MONTGOMERY COUNTY
PLANNING COMMISSION

SUBJECT: MCPC #18-0320-008
SOPI - 121 E City Pad Site

We have received and reviewed a "SOPI" submission for the above-referenced land development application as you requested on October 20, 2025. The comments in this memo are based on the most recent submission. We have attached our most recent full review letter (for submission MCPC #18-0320-008) for reference; however, some comments in our previous review letter(s) may have been addressed.

BALA CYNWYD SHOPPING CENTER: EAST-END REDEVELOPMENT

C-301

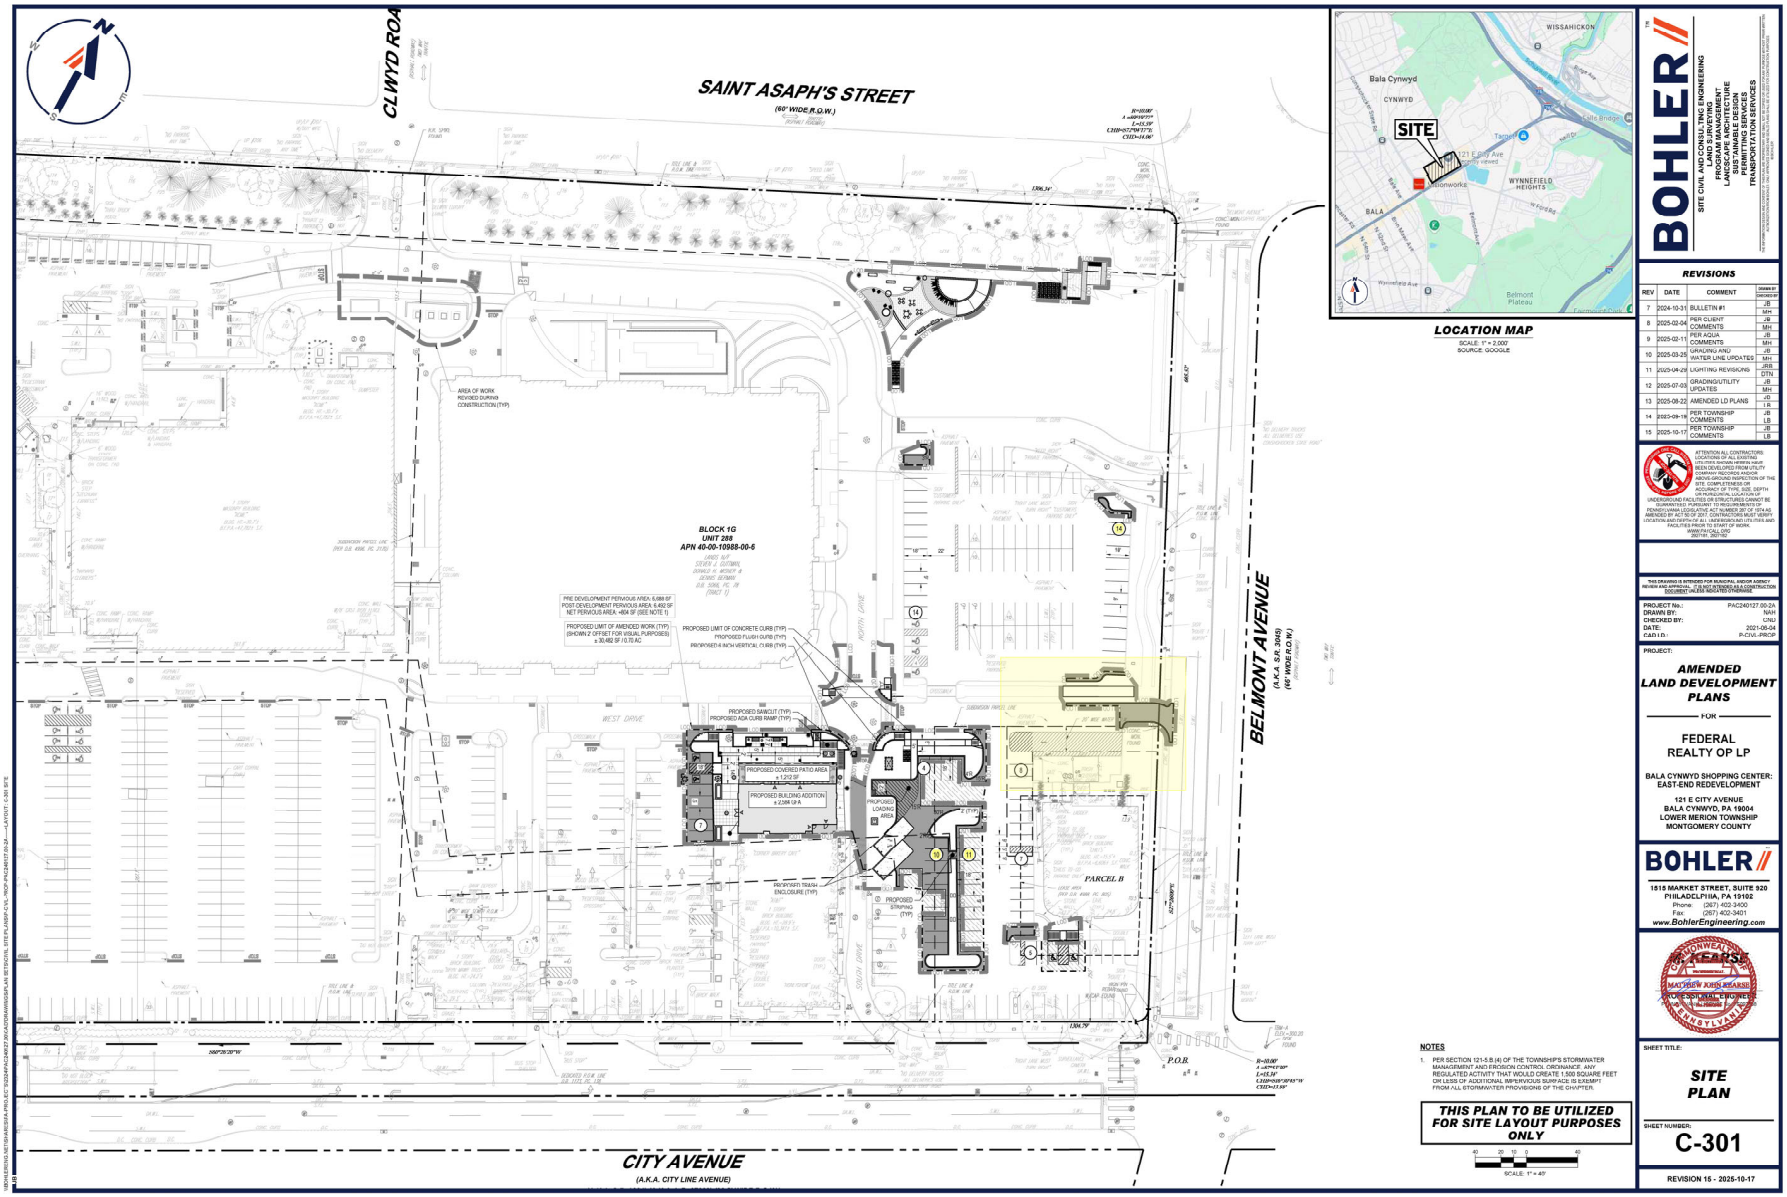
In addition, we wish to offer the following new comment in response to the revised parking lot configuration behind the existing building labeled "Chili's." Previous site plans showed a curbed and landscaped parking lot island defining the edge of the row of parking spaces on the west side of the existing building labeled "Chili's." The revised plans show this area being a striped pavement area instead. We encourage the applicant to explore whether the curbed and landscaped parking lot island could still be used in this location in order to define the edge of the row of parking spaces and separate the parking lot traffic flow from the traffic flow on the adjacent driveway off of Belmont Avenue.

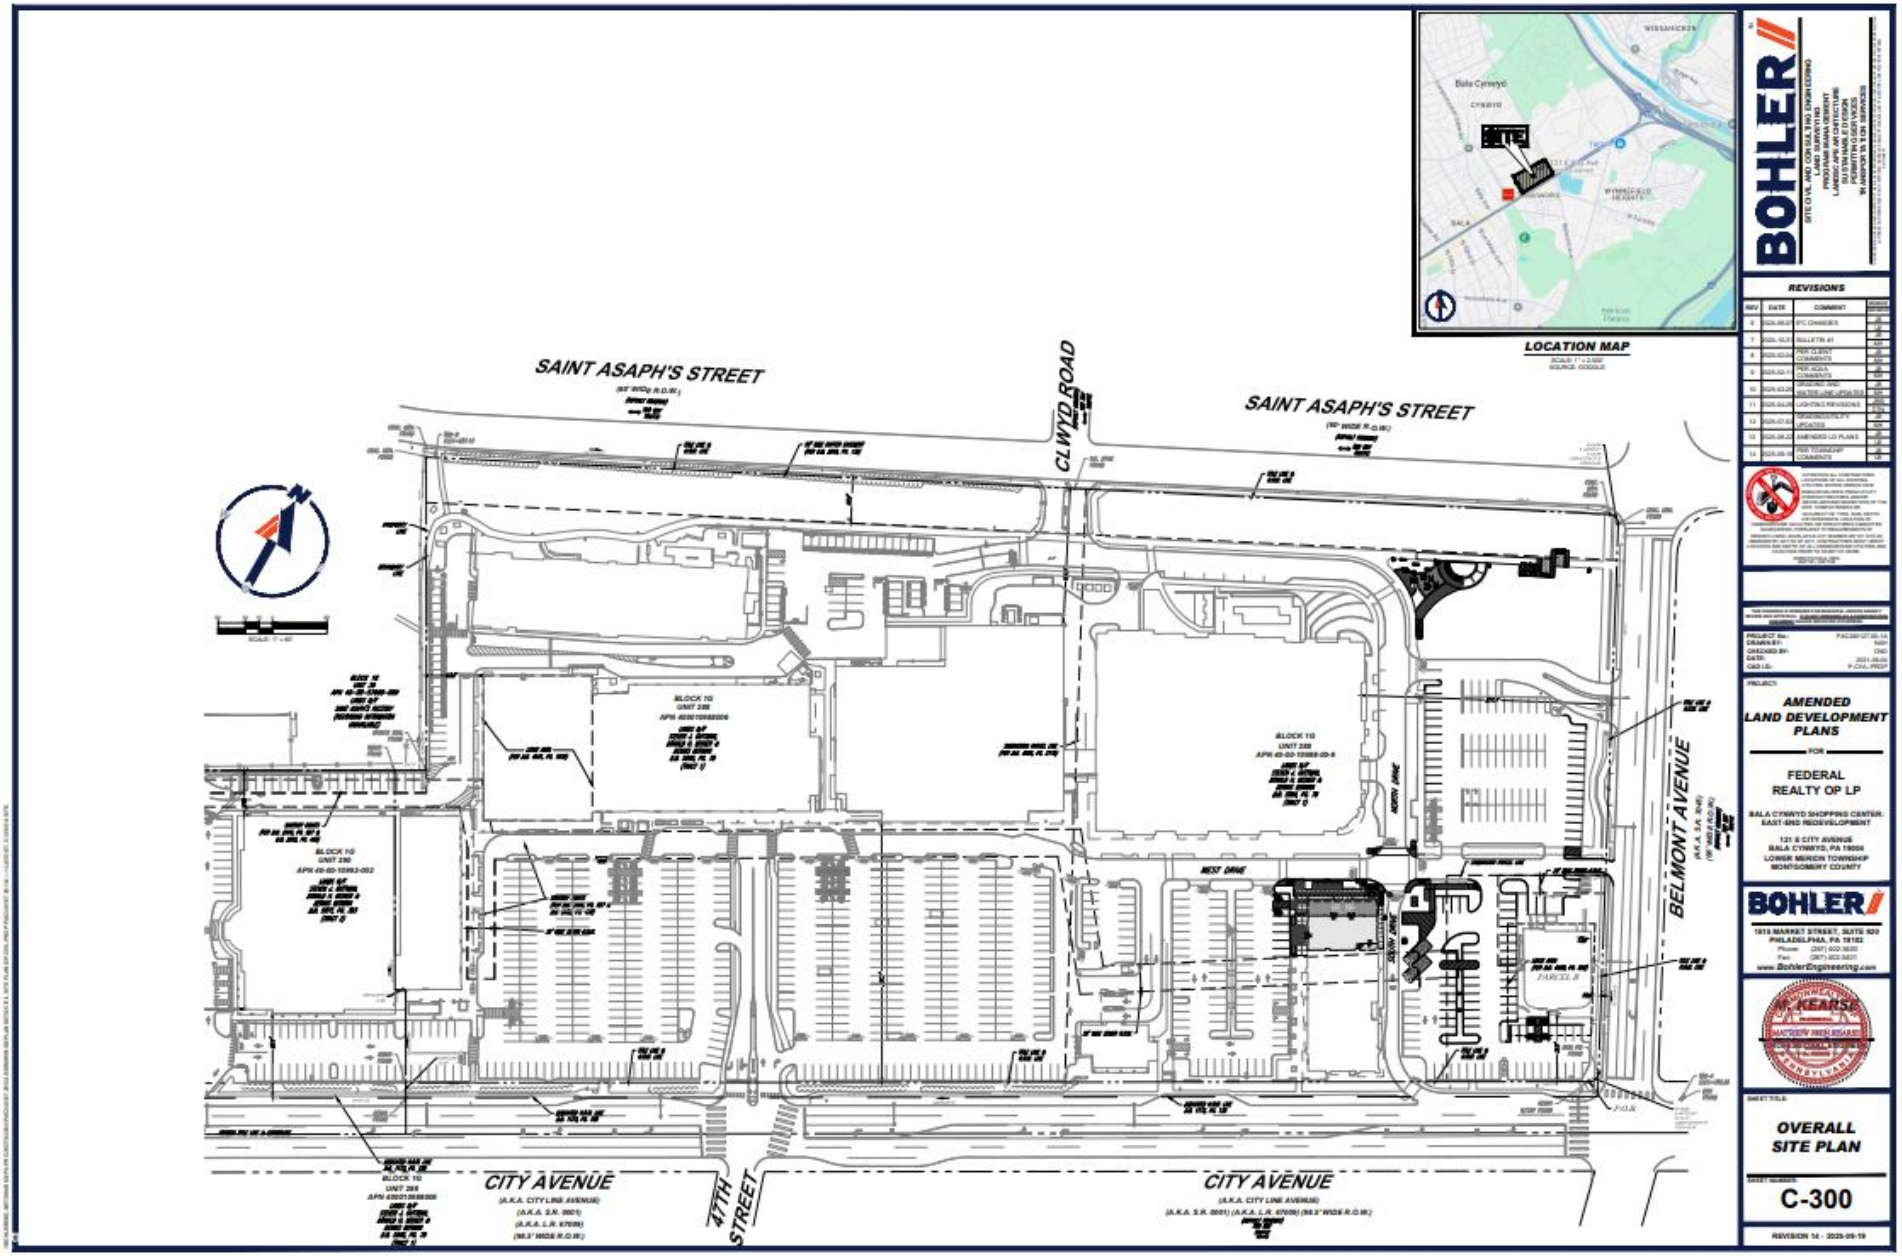
A. Minimum Building Height. Section 155-6.7.C.(2)(a) states that "the minimum height of any building shall be two stories and no less than 28 feet above grade." It appears that the applicant proposes a single-story building addition.

B. Development Design Standards. Section155-6.7.H. states that the development design standards provided in §155-6.6.I. shall also apply to the CAD-BCR District. Additional information may be helpful to determine compliance with the development design standards, as applicable. For example, §155-6.6.I.(5)(c)[5] states that "building corners at intersections of public streets shall be visually emphasized through design features […]." The proposed building addition will be located at the intersection of two proposed roads as shown on the City Avenue Official Map. Therefore, additional information regarding the design of the building addition as viewed from both frontages may be helpful.

Several bike racks are shown around the site; however, no bike racks were identified closest to the proposed building addition. We encourage the applicant to provide bike parking closer to the primary entrance of the proposed commercial building addition for the convenience of future patrons.
